The Commission has issued the enclosed Amendments Nos. 132, 132, and 129 to Facility Operating Licenses Nos. DPR-38, DPR-47 and DPR-55 for the Oconee Nuclear Station, Units Nos. 1, 2 and 3. These amendments consist of changes to the Station's common Technical Specifications (TSs) in response to your request dated September 11, 1984, as supplemented on October 22, 26, and November 1, 1984.

These amendments revise the TSs to support the operation of Oconee Unit 1 at full rated power during the upcoming Cycle 9. The amendments change the following areas:

SAFETY EVALUATION BY THE OFFICE OF NUCLEAR REACTOR REGULATION
SUPPORTING AMENDMENT NO. 132 TO FACILITY OPERATING LICENSE NO. DPR-38

OCONEE NUCLEAR STATION, UNITS NOS. 1, 2, AND 3

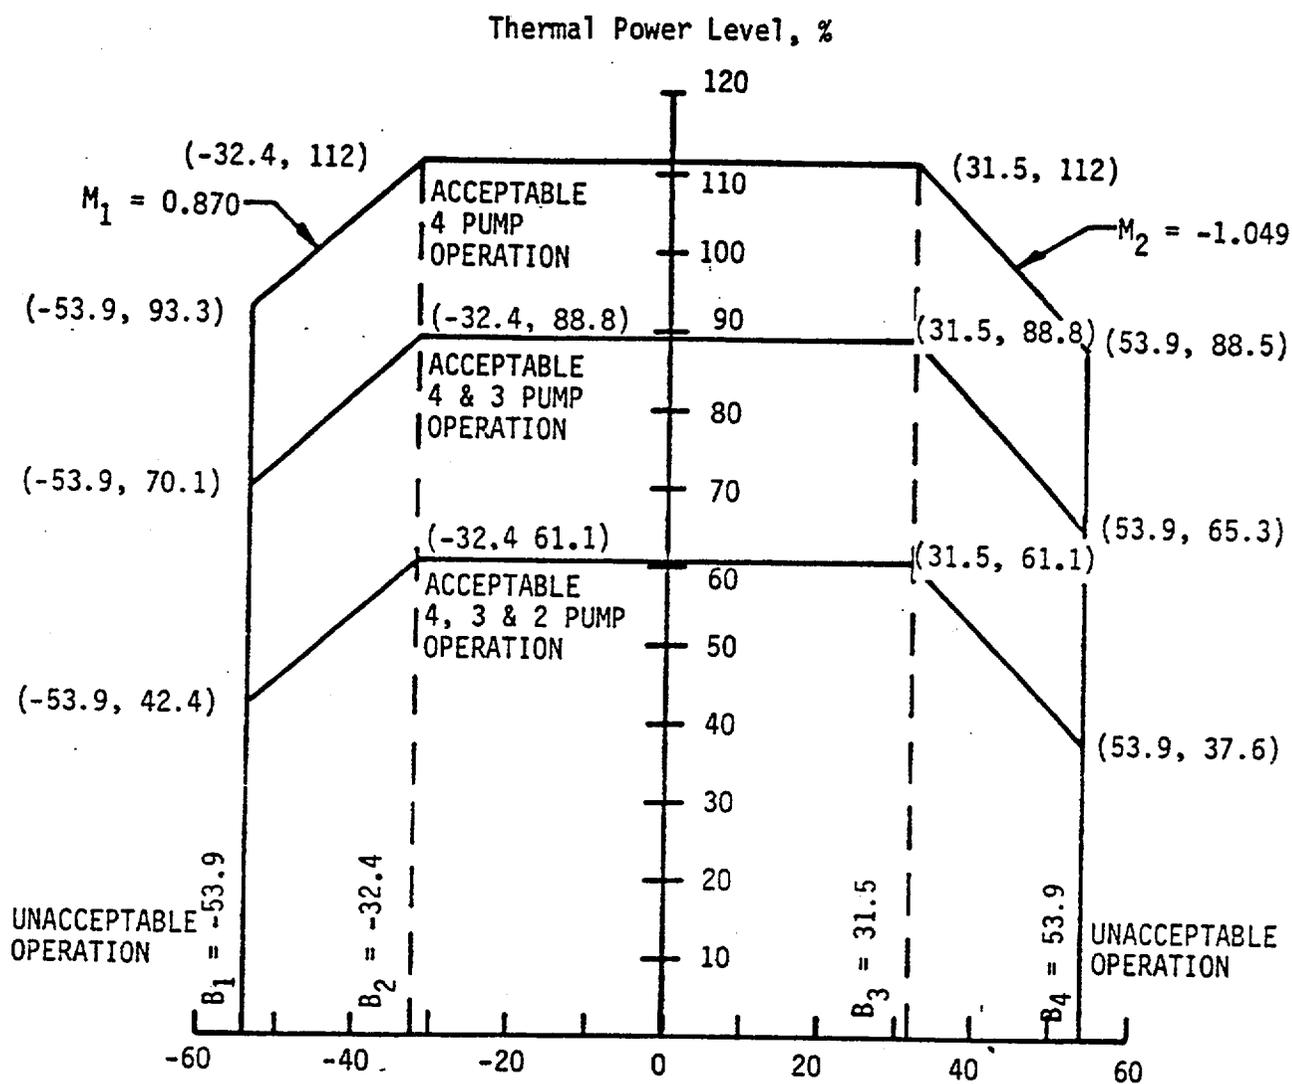
The curves of Figure 2.1-2A are based on the more restrictive of two thermal limits and include the effects of potential fuel densification and rod bowing:

The specified flow rates of Figure 2.1-3A correspond to the expected minimum flow rates with four pumps, three pumps, and one pump in each loop, respectively.

For each curve of Figure 2.1-3A a pressure-temperature point above and to the left of the curve would result in a DNBR greater than the CHF correlation limit or a local quality at the point of minimum DNBR less than the CHF correlation quality limit for that particular reactor coolant pump situation. The curve of Figure 2.1-1A is the most restrictive of all possible reactor coolant pump-maximum thermal power combinations shown in Figure 2.1-3A.

ROD POSITION LIMITS
 FOR FOUR PUMP OPERATION
 FROM 30 + 10/0 TO 250 + 10 EFPD
 UNIT 1

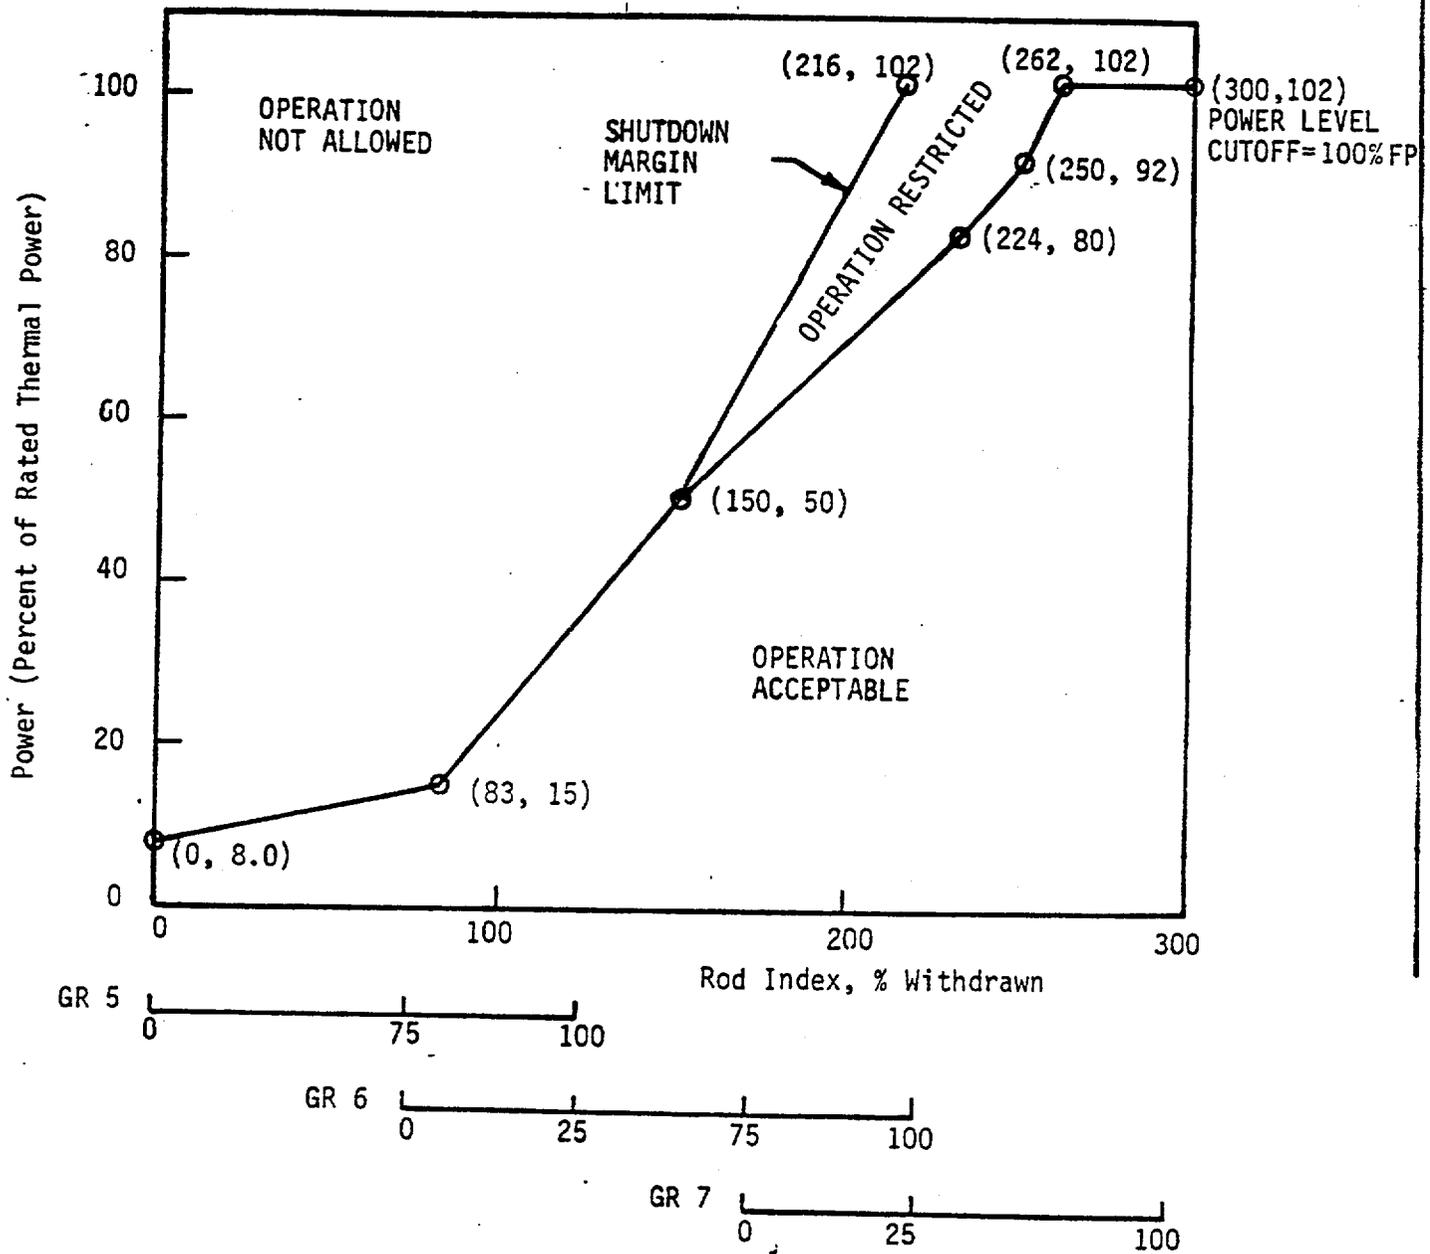
1. Core Protection Safety Limits (TS 2.1);
2. Protective System Maximum Allowable Setpoints (TS 2.3);
3. Rod Position Limits (TS 3.5.2); and
4. Power Imbalance Limits (TS 3.5.2).
